ECE3301L SESSION 1 LAB 2

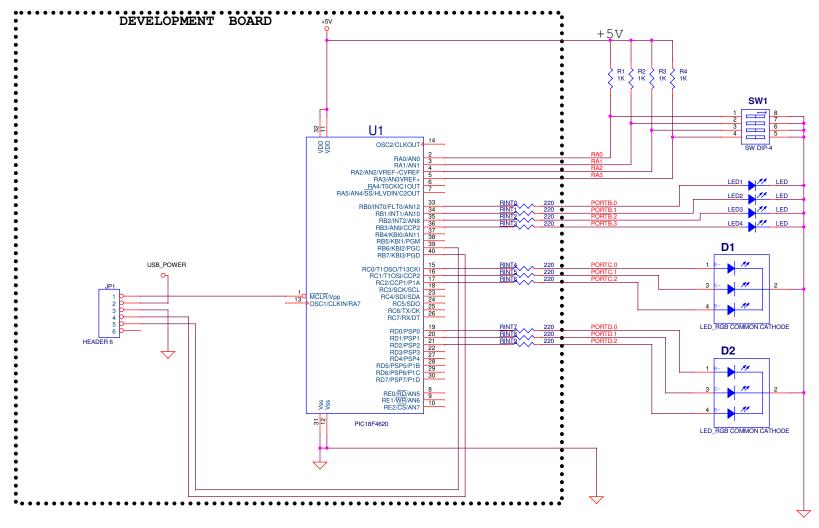
REMOVE THE JUMPER AT JP3 THAT IS CONNECTING PIN 1 TO 2 AND MOVE IT TO CONNECT FROM PIN 2 TO PIN 3. THIS WILL ALLOW THE SIGNAL 'RA3' TO WORK PROPERLY.
